SS 1033223 WST 4700 with Cummins engine: Hood strap wrapping around A/c pressure switch

WST 4700 with Cummins engine

Fig 1: hood strap shown in green rectangle

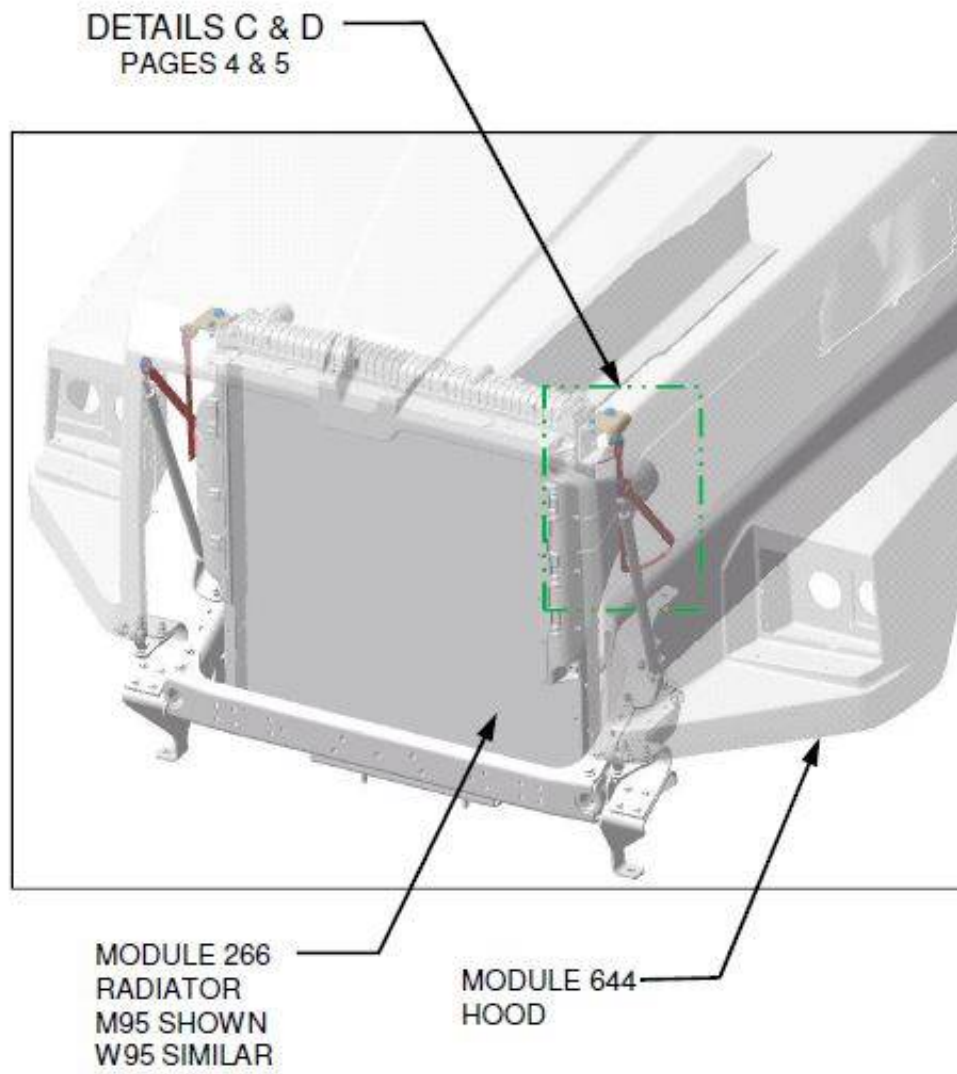
The hood strap on 4700s equipped with Cummins engines is liable to be tossed about by wind entering through the grille. The strap is long enough that it able to wrap around the A/C pressure switch as it is tossed in the wind.

Wrap a spiral wrap hose protector over the strap. This will weigh the strap down, preventing it from being tossed about, as well as helping it roll off the pressure switch if it gets hooked on it.

Fig 2: A/C Pressure switch next to strap, with improvement already installed

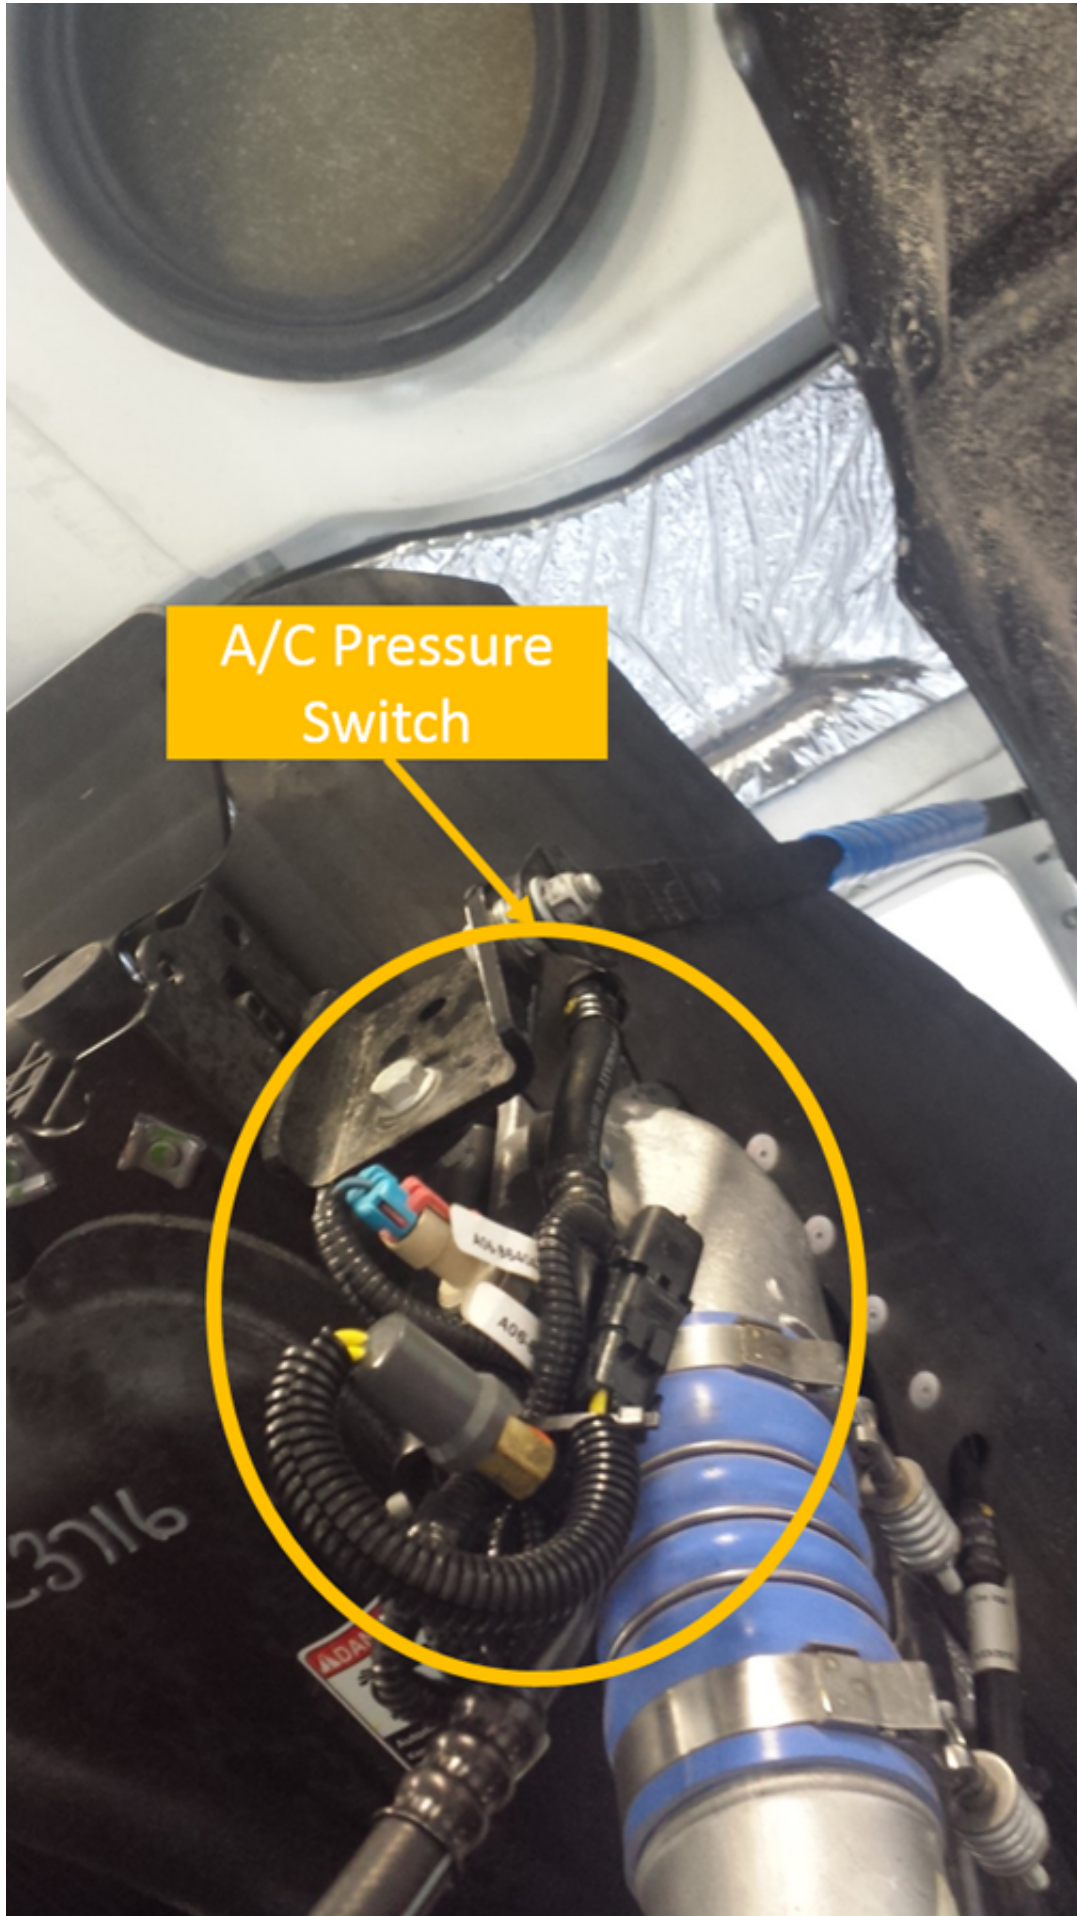
A/C pressure switch broken and/or hood strap wrapped around A/C pressure switch.
